Snapshot of main scheme changes and evolution

This annotated Illustrative Masterplan provides a snapshot of the main changes made as a result of consultation and through the design review and evolution process.

This snapshot is not exhaustive and does not detail all scheme changes – it aims to show the principal changes from the early 2016 draft Illustrative Masterplan to the summer 2018 draft Illustrative Masterplan, as submitted with the DCO application.

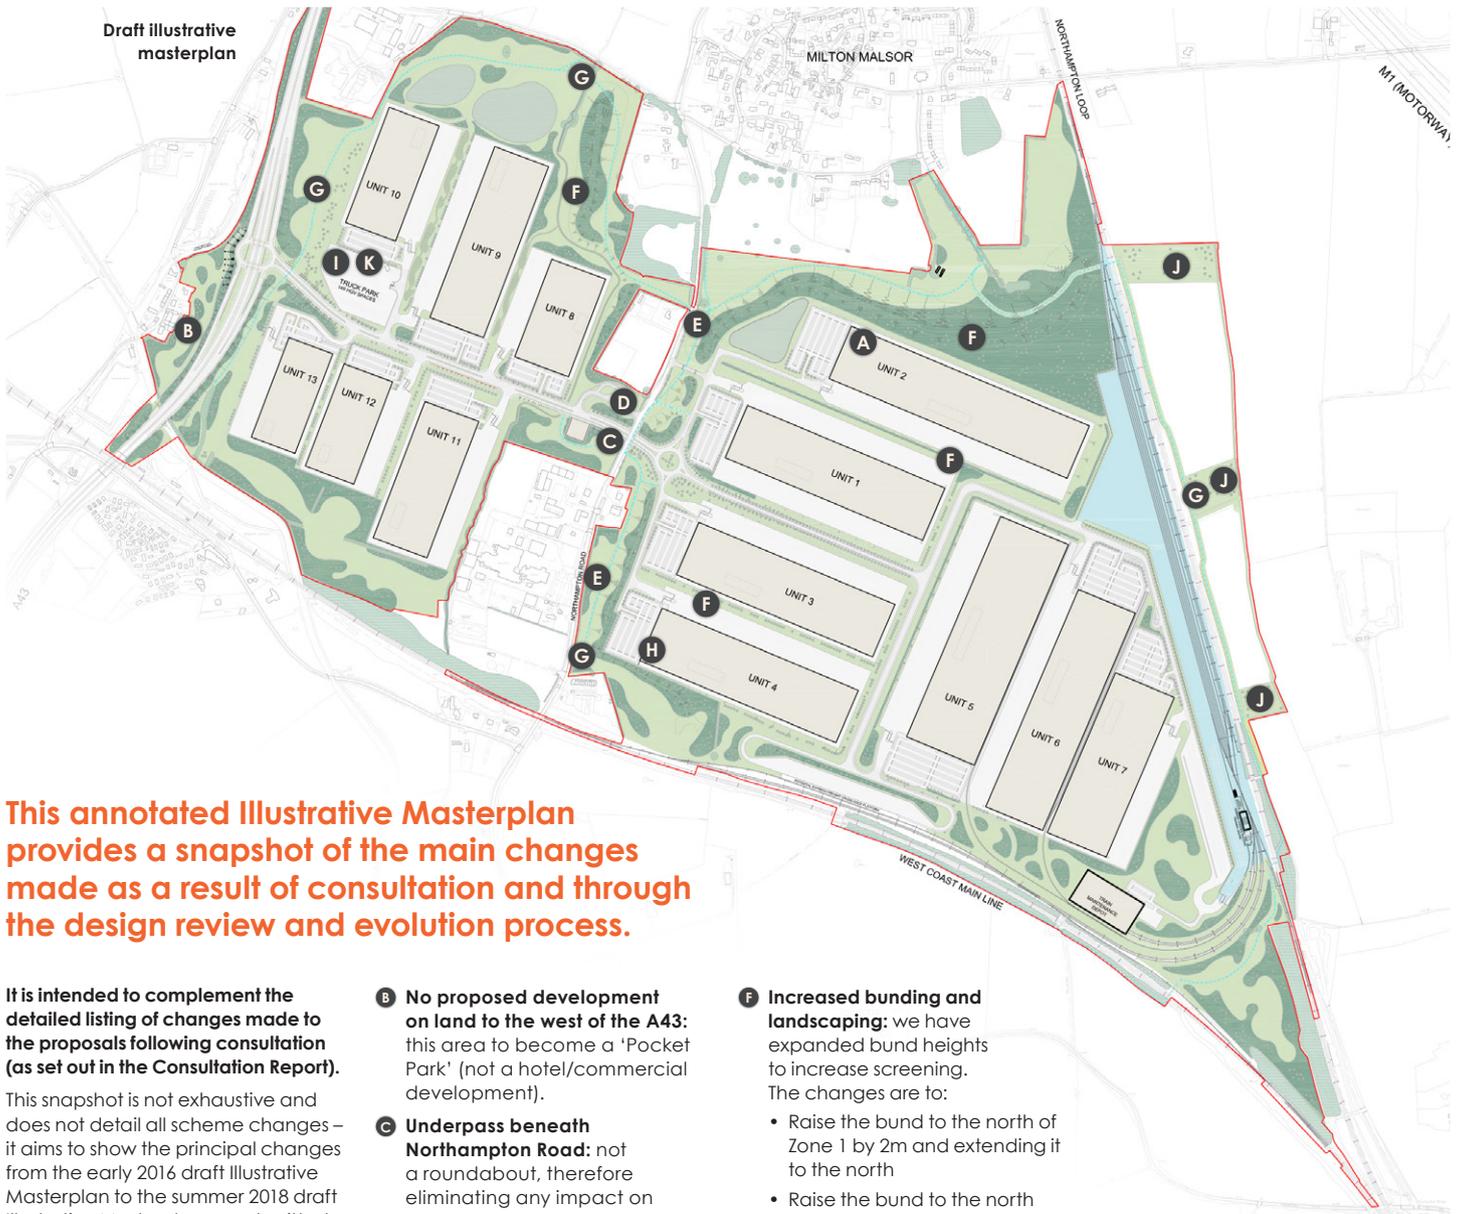
Overall, we have reduced the total commercial floorspace proposed from an initial approx. 8 million sq ft to approx. 7.4 million sq ft in response to feedback and to reduce visual impact.

Planting and screening has also been substantially reinforced to create stronger and more substantial landscaping buffers between the development and its setting.

A Building heights on northern area nearer to Milton Malsor: we have lowered and capped proposed building heights in Zone 3a (as per the Parameters Plan) from 18.5m to 15m. This is in direct response to concerns raised at Stage Two Consultation regarding visual impact.

B No proposed development on land to the west of the A43: this area to become a 'Pocket Park' (not a hotel/commercial development).

C Underpass beneath Northampton Road: not a roundabout, therefore eliminating any impact on Northampton Road and enabling site vehicles to move freely between the eastern and western parts of the site.

D Emergency only vehicle access off Northampton Road: staff/visitors and HGVs will not be able to access the site from Northampton Road and will all use the proposed new junction on the A43. There will be pedestrian/cycle access and when required emergency access from Northampton Road (controlled via gates by the emergency services).

E Northampton Road 'Greenway': establishing a clearer 'green corridor' parallel to Northampton Road to create a landscape and walking route linking the villages of Blisworth and Milton Malsor. The proposed buildings have also been set back from the existing road to provide an expanded landscape buffer.

F Increased bunding and landscaping: we have expanded bund heights to increase screening. The changes are to:

- Raise the bund to the north of Zone 1 by 2m and extending it to the north
- Raise the bund to the north of Zone 3a by 2m, excluding at the northern tip where it remains as before
- Reduce the ground levels in Zone 3a and 3b by 0.5m, and in Zone 4 by 0.35m

G Enhanced public rights of way and connectivity: better defined public rights of way (PROW) and footpaths through, around and alongside the site, including new routes to ensure that circular routes are maintained, especially along the eastern side of the Northampton Loop to link the existing footpath route back into Milton Malsor.

H Reorientation and reduction of selected warehouse buildings: to reduce the visual impact on Railway Cottages and Northampton Road, the distance between the closest buildings (Units 3 and 4) has been increased. Unit 4, which is closest to the Railway Cottages, has also been reduced in size.

I Increased lorry park capacity: we have increased capacity of the lorry park to the south of Unit 10 to further alleviate concerns over HGVs potentially parking on local roads.

J Additional woodland planting to the east of the Northampton Loop Line: we are proposing woodland blocks to the east of the Northampton Loop in keeping with the wider landscape character.

K Occupational health: we have added on-site occupational health facilities within the planned lorry park amenities.
